GENERAL ELECTRIC
FUEL SWELL AND RUPTURE MODEL
EXPERIMENTAL DATA REVIEW
AND
SENSITIVITY STUDIES

May 12, 1981

FIGURE 7: COMBINATION OF NUREG-0630 SLOW AND FAST HEAT-UP RATE CORRELATIONS

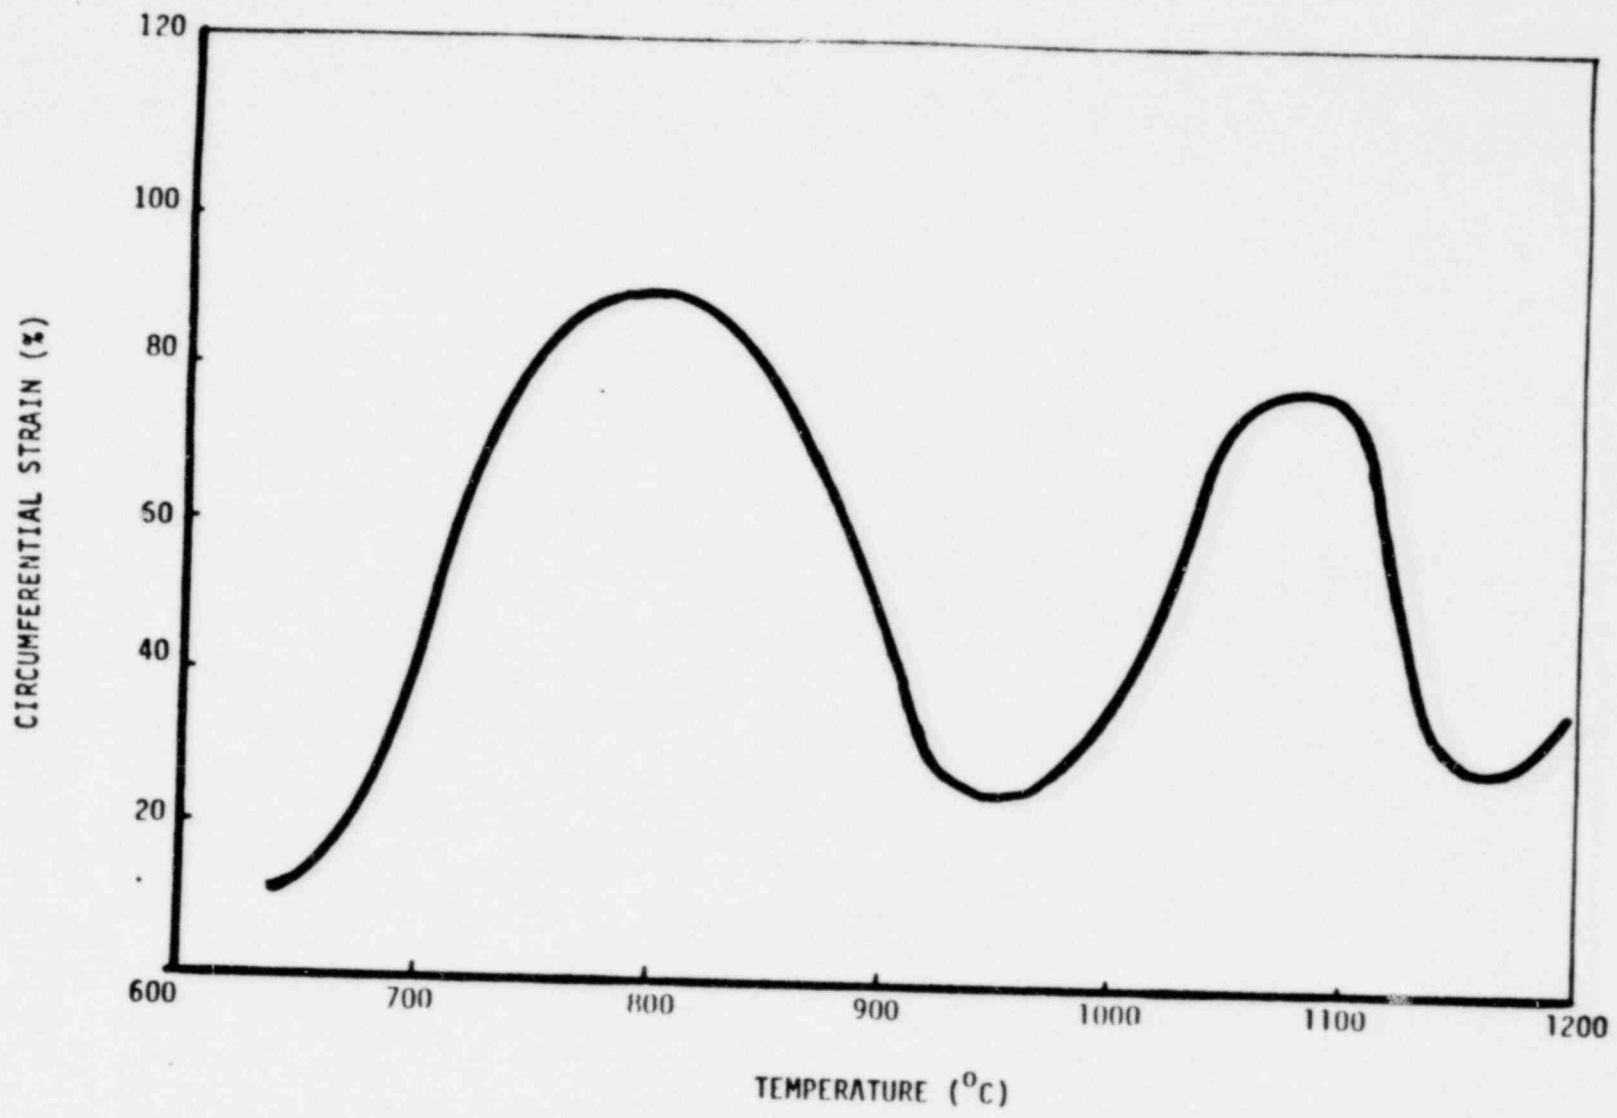
The NRC staff is also requesting (Reference 2) that supplemental calculations be performed with a combination of the slow and fast heat-up rate circumferential strain versus temperature curves from NUREG-0630. This combination of the slow and fast ramps (shown in Figure 7) is biased to produce the maximum strain at any given temperature.

General Electric does not believe that the NUREG-0630 strain-temperature curves are sufficiently qualified to warrant application to GE BWR fuel. Furthermore, the combination of the slow and fast ramp curves represents a further departure from applicability to BWR fuel. The following paragraphs provide the technical basis for this position.

FIGURE 9: NUREG-0630 DATA FOR HEAT-UP RATES $\leq 10^0$ F/SEC

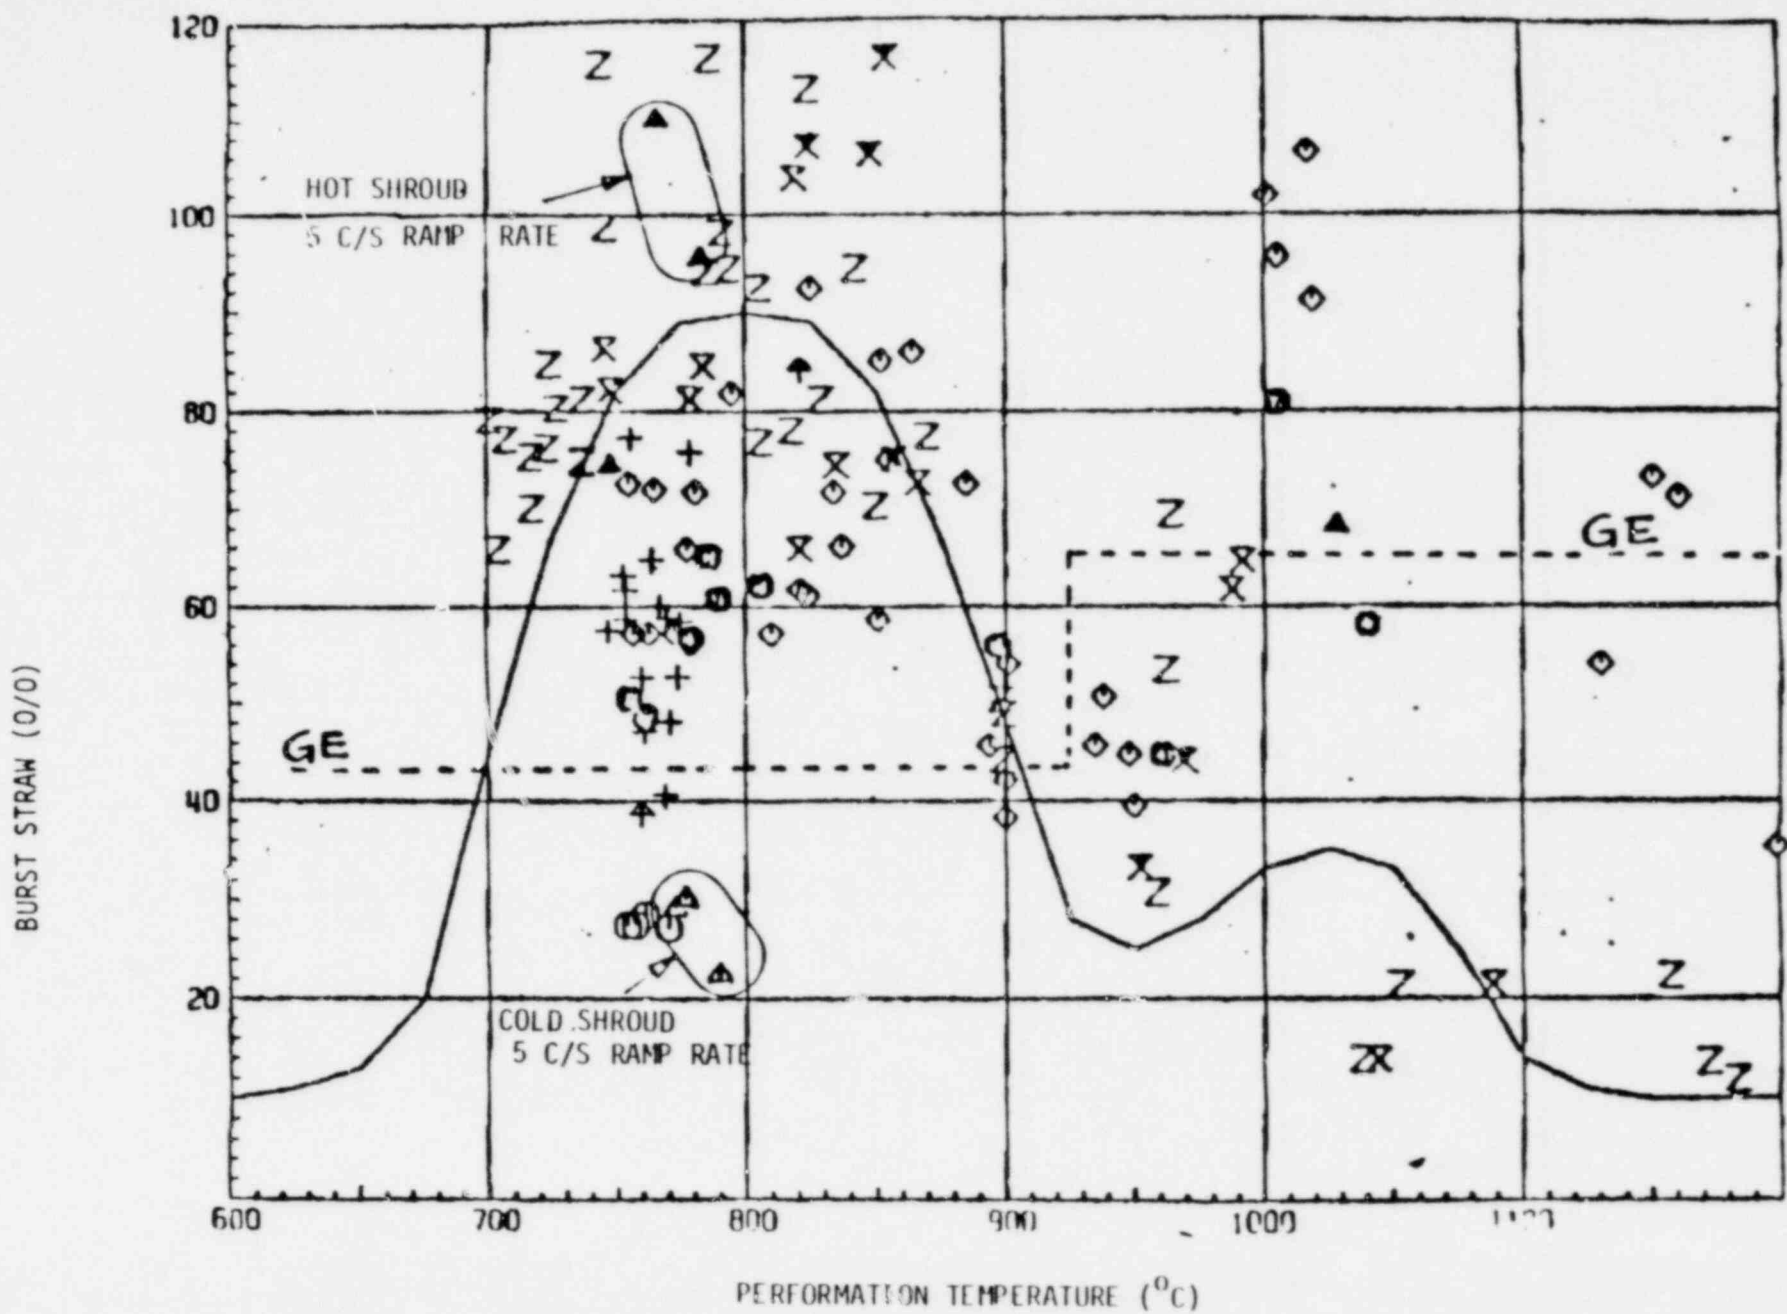
Figure 8 shows the General Electric perforation strain-temperature model together with the founding data base for heatup rates of $\leq 10^{\circ}\text{F}/\text{second}$. This figure shows that the GE model conservatively bounds greater than 90% of the data. Figure 9 shows the GE model compared to the slow heatup correlation from NUREG-0630 together with the NUREG-0630 data for heatup rates of $\leq 10^{\circ}\text{F}/\text{sec}$. It is apparent from this figure that the NUREG-0630 correlation is unqualified for temperatures above $\sim 1600^{\circ}\text{F}$. Furthermore, General Electric also questions the criteria used to select the data from which the curve has been derived. In NUREG-0630, it is stated that most of the data falling below this curve were discounted, as they were from tests with features known to reduce perforation strains.

i.e., non-uniform temperature profiles, corrosion fission products and cold shrouds. However, all these features would be present in a BWR during a LOCA. For example, a large number of BWR rods can freely radiate to a cold surface (fuel channel or water rods) during a LOCA thus establishing significant temperature variations. Furthermore, significant axial temperature variations, also known to reduce cladding strain (Reference 7), occur due to the stochastic stacking and tilting of the fuel pellets within the fuel column. Therefore, as the majority of the data used must have been obtained under conditions (heated shroud, uniform temperature) which are not prototypical of the BWR, the applicability of any correlation derived from this data is questionable.

Figure 11. RUPTURE STRAIN vs. RUPTURE TEMPERATURE

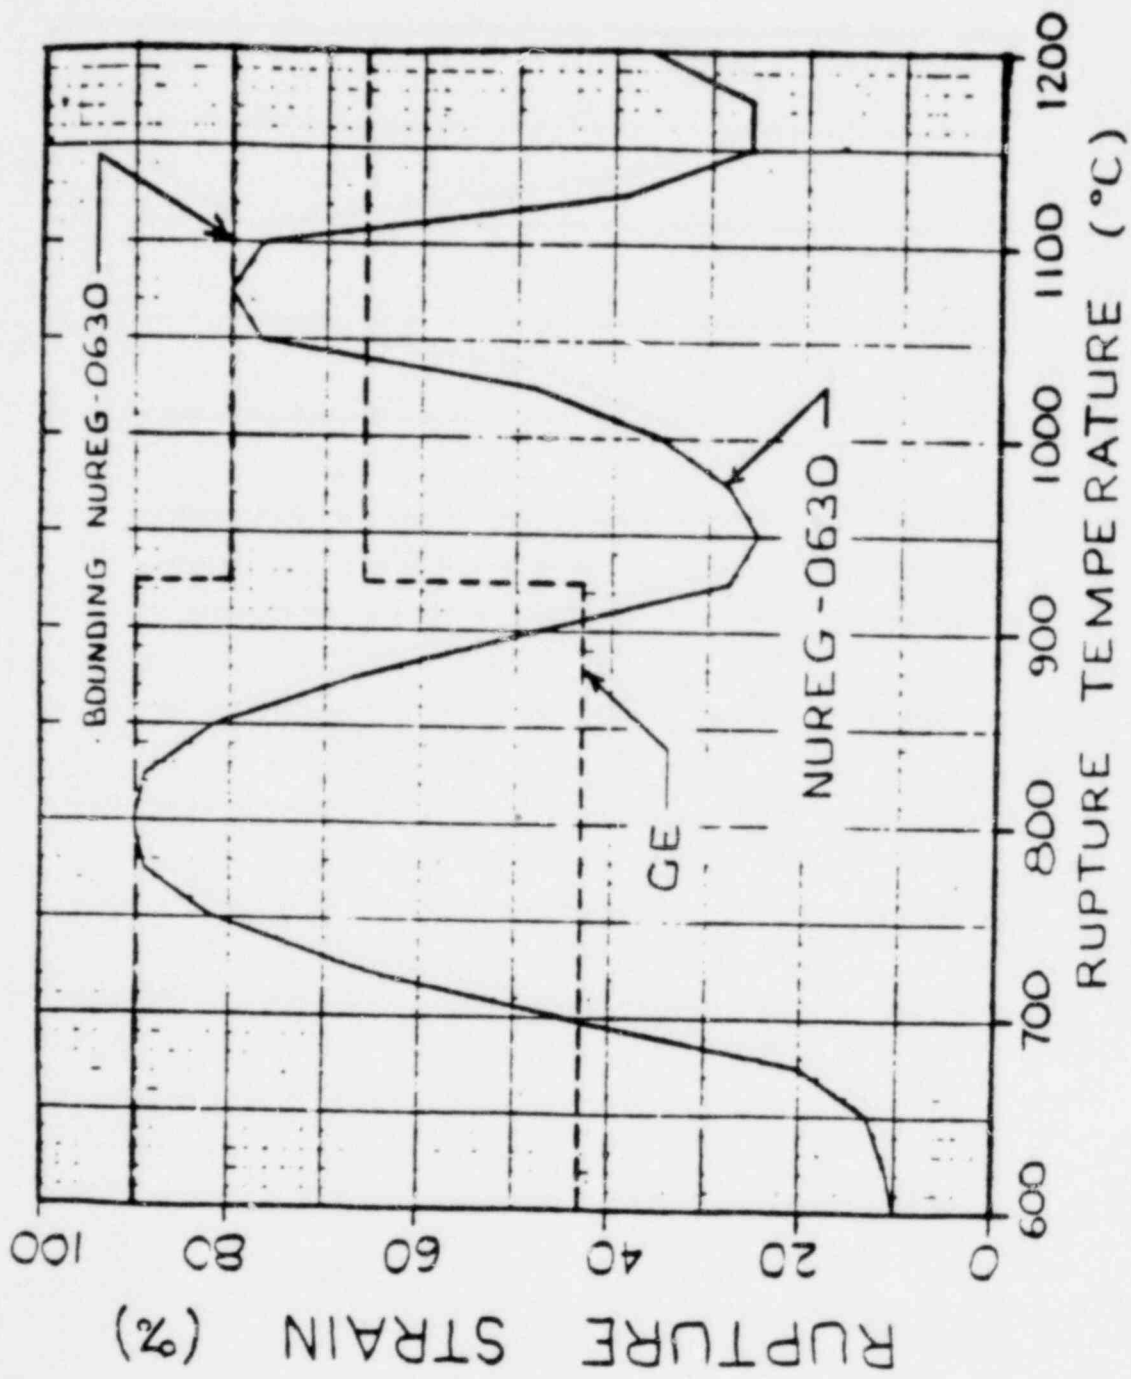
The purpose of this study was to determine the effect of cladding strain at perforation on calculated PCTs. The GE and bounding NUREG-0630 rupture strain curves (Figure 11) were used for the comparison. The results show a small (0 to 5°F) PCT decrease with bounding NUREG-0630 strains. This is because even though individual rod temperatures are affected (by as much as 20°F just after a rod perforates during the transient), the temperature of all the rods in the bundle tends to equalize as a result of redistribution of energy by radiation heat transfer. Consequently, the overall effect on PCT is small. The studies show that as the strain is increased on an individual rod its temperature decreases, because for larger strains there is a larger area for heat transfer. For smaller strains the temperatures are higher as the area for heat transfer is smaller.

The conclusion from this study is that the cladding temperature of perforated rods is relatively insensitive (<10°F, 15 seconds after perforation) and the PCT is almost completely insensitive to the perforation strains. Hence, continued use of the General Electric strain values is considered appropriate.
